#2015-36

Bryn Mawr Conceptual PUD

Project Review for Planning and Zoning Commission

<u>Meeting Date:</u>	June 17, 2015
<u>Request:</u>	Conceptual PUD review for a single-family and multi-family subdivision.
<u>Location:</u>	N. Route 176, east of Route 47
<u>Acreage:</u>	Approximately 197 acres
<u>Existing Zoning:</u>	RE- Residential Estate PUD and O-Office PUD with Conservation Overlay
<u>Proposed Zoning:</u>	R-2 PUD Single-Family Residential and R-3B Multi-Family Residential with Conservation Overlay
<u>Surrounding Properties:</u>	North: A1- Agriculture (McHenry County) South: E- Estate (Crystal Lake) and B-2 General Business (Village of Lakewood) East: RE- Residential Estate PUD West: AG- Agricultural (Village of Lakewood)
<u>Staff Contact:</u>	Kathryn Cowlin (815.356.3615)

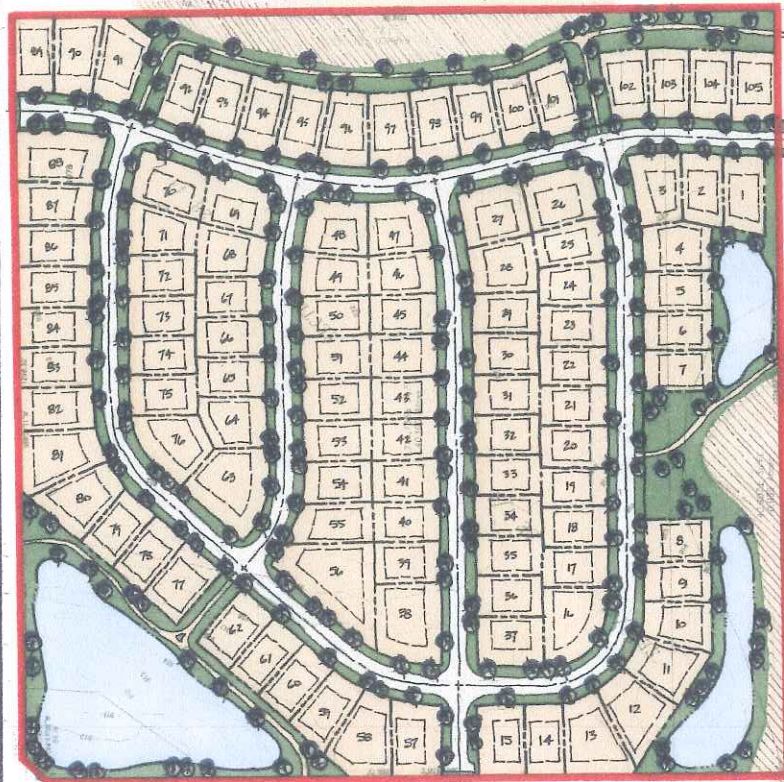
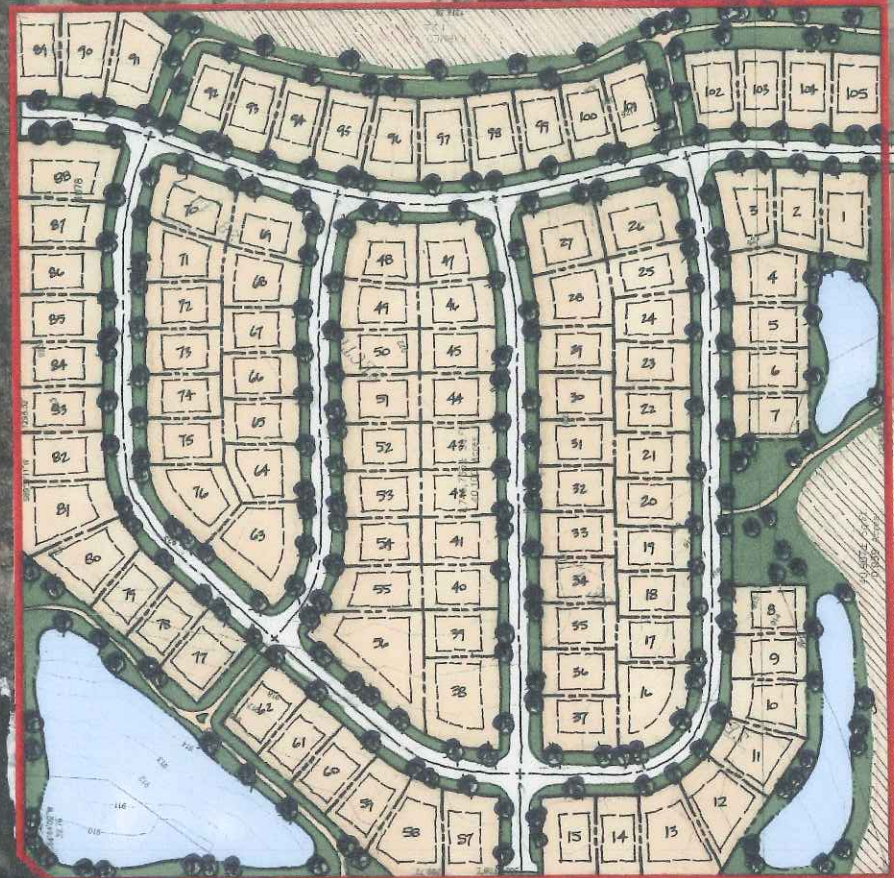
- The total numbers of allowable dwelling units on site for the proposed densities are below. Density was calculated using the Conservation Overlay District formula.
 - Single-Family area based on R-2 net density: 219.41 dwelling units allowed (**323 units proposed, density bonus required**).
 - Multi-Family area based on R-3B net density: 108.36 dwelling units (**204 units proposed, density bonus required**).

- The site layout illustrates 323 single-family residential lots.
- The site layout illustrates 34 townhome buildings with 6 units, totaling in 204 townhomes.
- The existing wetland area is being preserved.
- Multi-use paths provide access for residents to the natural areas.
- The proposed roadways would be consistent with the conservation overlay design guidelines- 20-foot wide with a ribbon curb and no parking on both sides of the street.
- Phase II would connect with Phase I of Bryn Mawr via Fabius Street, Helen Street, and Bryn Mawr Lane.
- Access on route 176 is proposed.

1. The site is predominately zoned Residential Estate, would R-2 Single-Family Residential and R-3B Multi-Family Residential be appropriate for this area?
2. Phase I of Bryn Mawr consists of single-family half-acre lots; does the proposed plan (R-2 zoned lots averaging 10,000 square feet) complement the character of Phase I?
3. Is the site layout appropriate?
4. Is the proposed density consistent with your vision for this area of Crystal Lake?
5. The Police Department has concerns that the proposed layout on the north parcel only has one access, is this acceptable?

6. The Boundary Line Agreement with Lakewood requires a 300-foot greenway buffer, which prohibits any building, structure or sign within the buffer. Would amending these requirements for this development be appropriate?
7. Though it is not proposed, would commercial zoning be acceptable along Route 176 to service this development and the future development of Lakewood?
